# Sol Tech N°0018

## PSU Modifications for Light bar issue 08-L301HA4-PW200AX

Here’s the picture of resistor location in power supply board.

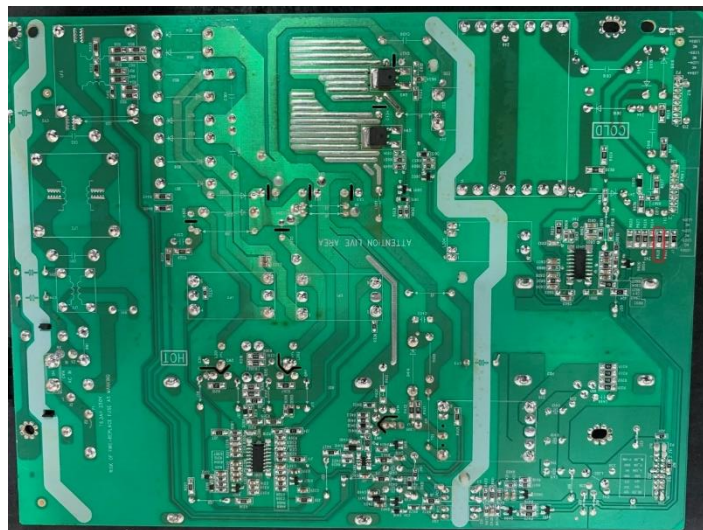
- All light bars from the TV must be replaced.
- After the replacement of light bars, ASP needs to modify the PSU as follows:

PSU Part Number	Original backlight current	Required change on PSU	Modified backlight current
08-L301HA4-PW200AB	300mA	Change R628 from 10Ω to 22Ω	246mA
08-L301HA4-PW200AA	300mA	Change R628 from 10Ω to 22Ω	246mA

Please change the original resistor from the position R628 on PSU.

- From 19-CD0100-FTX (10Ω) to 19-CD0220-JTX (22Ω).
